**3070-75A-S**

# **S E R V I C E N O T E**

## Agilent 3070 Board Test Systems

**The E1135A/B/C PDU may not turn off when the EMO switch (emergency stop) is pressed.**

**Fig 1**

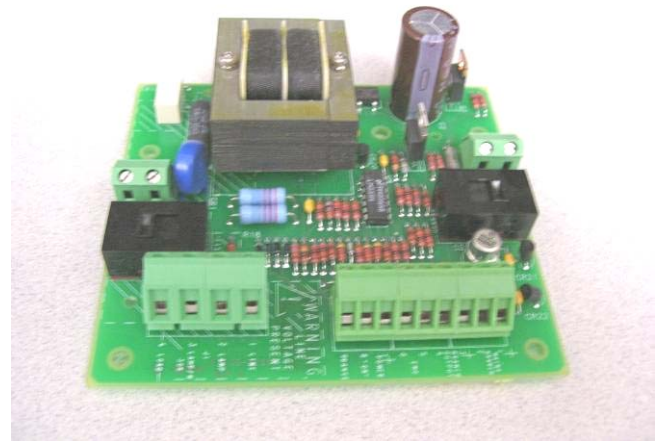
Agilent has identified an operational safety hazard for the 3070 systems related to the 0490-2318 magnetic contactor within the E1135A/B/C PDU. The MPN for the magnetic contactor is Potter and Brumfield P40P47D14P1-24.

Investigations revealed that the DC voltage supplied to the 0490-2318 from the E1135-66501 control board was higher than specified as there was no voltage regulation. Over time, excess heat can damage the coil of the magnetic contactor which leads to the described safety hazard.

The solution is to replace the E1135-66501 control board in the PDU with a newer version (Fig 1) that incorporates a voltage regulator to the magnetic contactor.

Fig 7

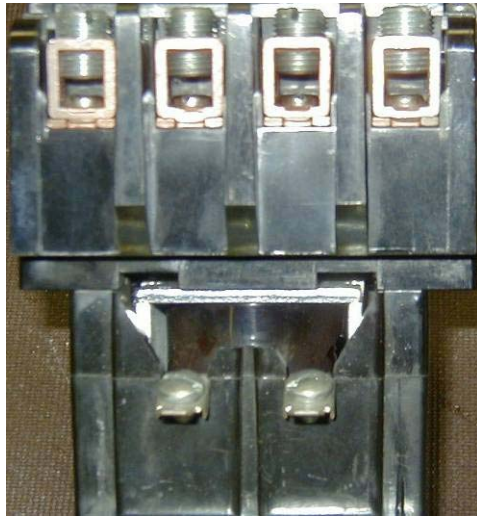
8. After opening the PDU. Inspect the contactor housing for cracks and “white” powder type material (Fig 8). If the contactor has been or is suspected to be damaged, the entire PDU must be replaced by following the PDU Replacement procedure. If the contactor is good (Fig 7) continue with step 9.

Fig 9

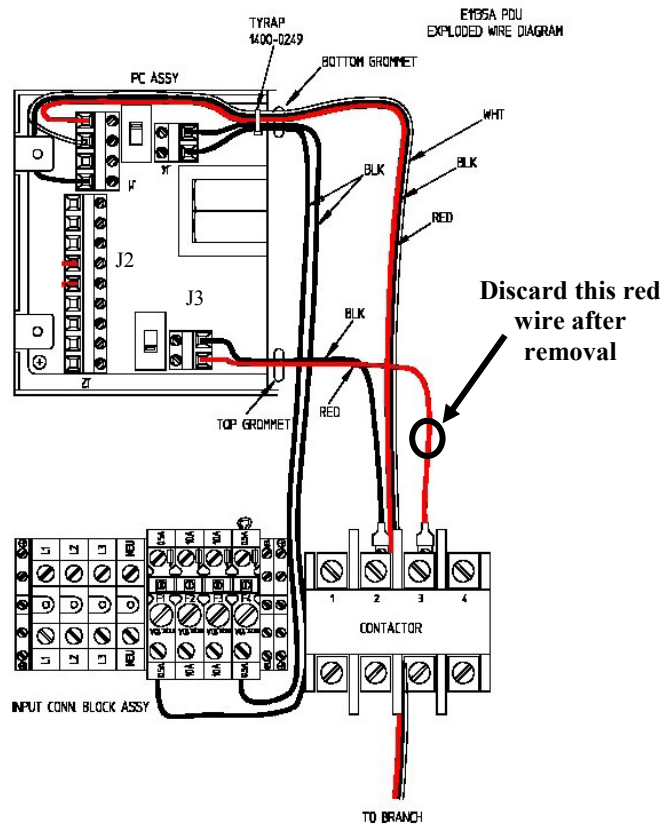
9. Remove the wires from the control board by using a small flat blade screwdriver. (Fig 9)
10. Make note of wire connections to J2 of control board.
11. Discard the red wire that was connected between “Contactor pin 3” and “J3 pin 1 control board”.

**Fig 11**

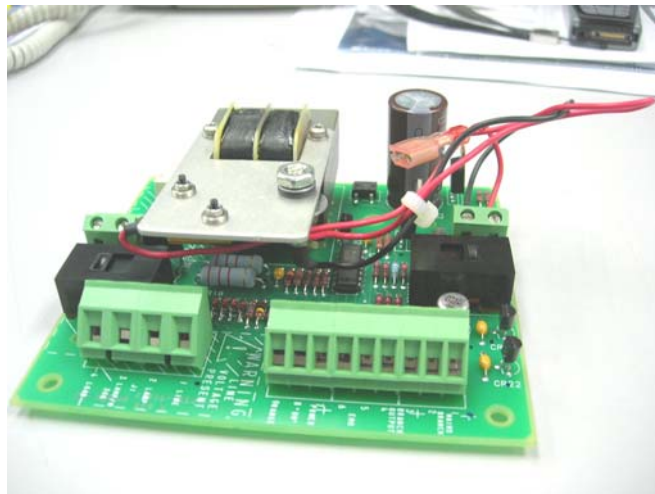
13. Remove the old control board from the PDU and discard.
14. Install the new control board (Fig 11) into the PDU using the five M4 Torx screws removed in step 12. Tighten these screws using a T20 Torx driver and torque to 16 inch-lb (1.81 n-meter)

Fig 12

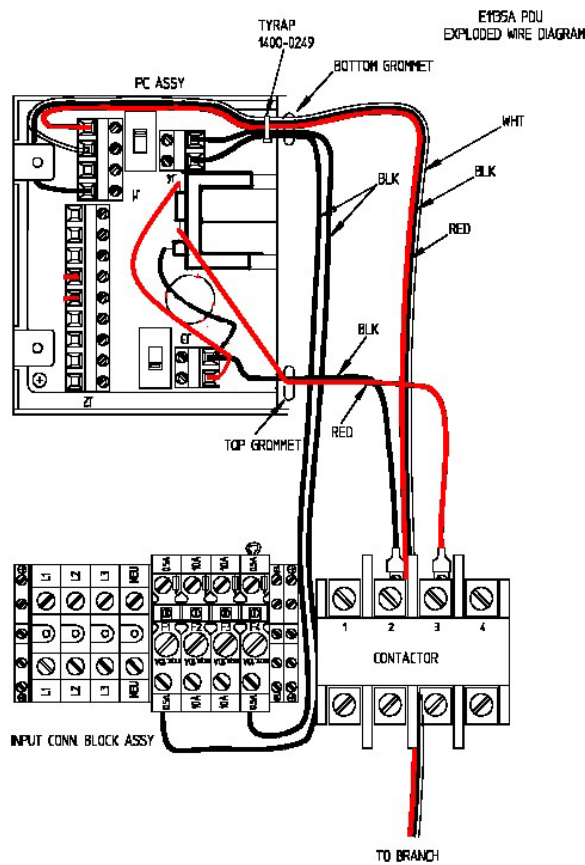
- Re-wire the control board using the wiring diagram in Figure 12 and wires removed from J2 on the control board in step 10.

Control Board to Contactor Connections		
Black Wire Contactor Pin 2	to	Control Board J3 pin 2
Black Wire Control Board J3 pin 2	to	Regulator on Control Board
Red Wire Contactor Pin 3	to	Regulator on Control Board
Red Wire Control Board J3 pin 1	to	Regulator on Control Board

**Note:** Wires from Regulator to J3 on control board are already connected when received from SPO.
